Addendum 116 – UN Regulation No. 117

Revision 4 - Amendment 7

03 series of amendments – Date of entry into force: 4 January 2023.

Uniform provisions concerning the approval of tyres with regard to rolling sound emissions and/or to adhesion on wet surfaces and/or to rolling resistance

"Annex 2 - Appendix 1

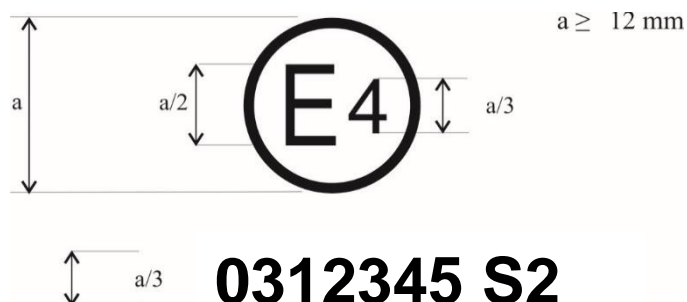
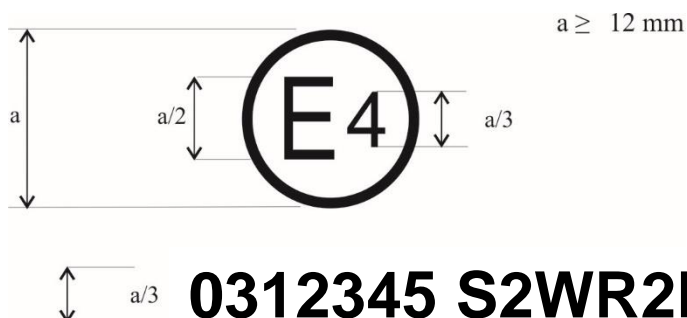
Annex 2, Appendix 1, amend to read:

The above approval mark, affixed to a tyre shows that the tyre concerned has been approved in the Netherlands (E4) pursuant to UN Regulation No. 117 (marked by S2 (rolling sound emission at stage 2)), under approval number 0312345. The first two digits of the approval number (03) indicate that the approval was granted according to the requirements of the 03 series of amendments to this Regulation.

The above approval mark shows that the tyre concerned has been approved in the Netherlands (E4) pursuant to UN Regulation No. 117 (marked by S2 (rolling sound emission at stage 2), W (wet adhesion of tyres in new state), R2 (rolling resistance at stage 2) and B (wet adhesion of tyres in worn state)) under approval number 0312345. The first two digits of the approval number (03) indicate that the approval was granted according to the requirements of the 03 series of amendments to this Regulation."

"Annex 2 - Appendix 2

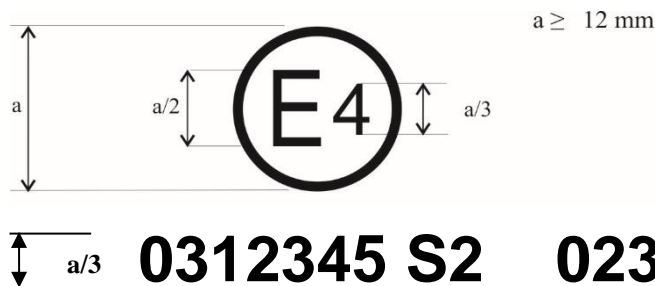
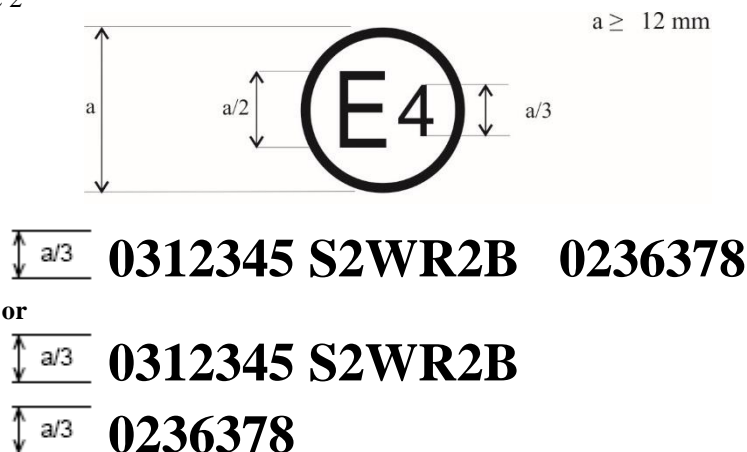
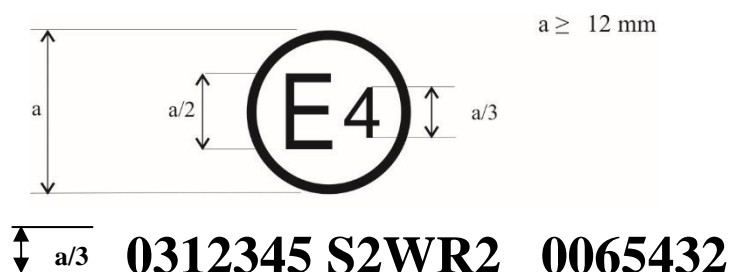
Annex 2, Appendix 2, amend to read:

The above approval mark shows that the tyre concerned has been approved in the Netherlands (E4) pursuant to UN Regulation No. 117 (marked by "S2" (rolling sound emission at stage 2)), under approval number 0312345 and UN Regulation No. 30, under approval number 0236378. The first two digits of the approval numbers ("03" and "02") indicate that the approval pursuant to UN Regulation No. 117 was granted according to the 03 series of amendments and the approval pursuant to UN Regulation No. 30 according to the 02 series of amendments.

The above approval mark shows that the tyre concerned has been approved in the Netherlands (E4) pursuant to UN Regulation No. 117 (marked by "S2WR2B" (rolling sound emission at stage 2, wet adhesion of tyres in new state, rolling resistance at stage 2 and wet adhesion of tyres in worn state)), under approval number 0312345 and UN Regulation No. 30 under approval number 0236378. The first two digits of the approval numbers ("03" and "02") indicate that the approval pursuant to UN Regulation No. 117 was granted according to the 03 series of amendments and the approval pursuant to UN Regulation No. 30 according to the 02 series of amendments.

The above approval mark shows that the tyre concerned has been approved in the Netherlands (E4) pursuant to UN Regulation No. 117 (marked by "S2WR2" (rolling sound emission at stage 2, wet adhesion of tyres in new state and rolling resistance at stage 2)), under approval number 0312345 and UN Regulation No. 54 under approval number 0065432. The first two digits of the approval numbers ("03" and "00") indicate that

"Annex 2 - Appendix 3

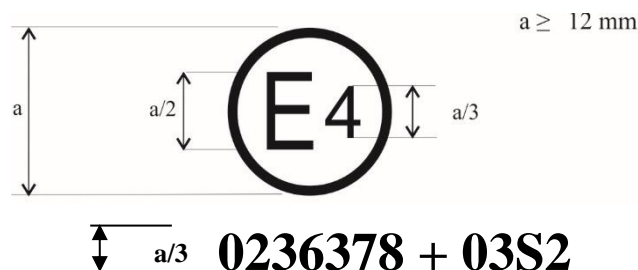
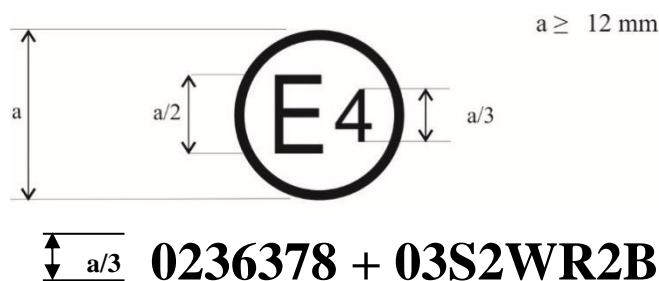
Annex 2, Appendix 3, amend to read:

The above approval mark shows that the tyre concerned has been approved in the Netherlands (E4) pursuant to UN Regulation No. 30 according to its 02 series of amendments (indicated by the first two digits of the approval number, "02") under approval number 0236378. It is also marked by "+ 03S2" which indicates that the tyre was also approved pursuant to UN Regulation No. 117 (03 series of amendments) for S (rolling sound emission at stage 2).

The above approval mark shows that the tyre concerned has been approved in the Netherlands (E4) pursuant to UN Regulation No. 30 according to its 02 series of amendments (indicated by the first two digits of the approval number, "02") under approval number 0236378. It is also marked by "+ 03S2WR2B" which indicates that the tyre was also approved pursuant to UN Regulation No. 117 (03 series of amendments) for S (rolling sound emission at stage 2) W (wet adhesion of tyres in new state), R (rolling resistance at stage 2) and B (wet adhesion of tyres in worn state)."

"Annex 2 - Appendix 4

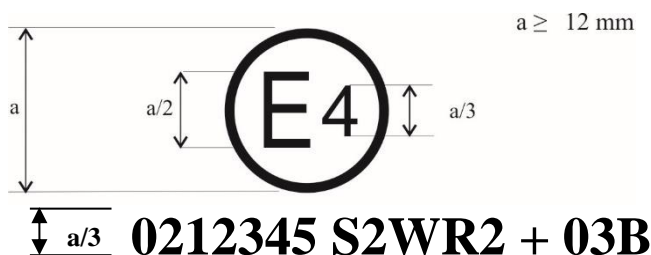
Annex 2, Appendix 4, amend to read:

The above approval mark shows that the tyre concerned has been initially approved in the Netherlands (E4) pursuant to UN Regulation No. 117 and the 02 series of amendments under approval number 0212345. The marking is complemented by S2WR2 (rolling sound emission at stage 2) W (wet adhesion of tyres in new state) and R (rolling resistance at stage 2) The "03B" preceded by "+" indicates that it has had its approval extended under UN Regulation No. 117 and 03 series of amendments to wet adhesion of tyres in worn state based on separate certificate."
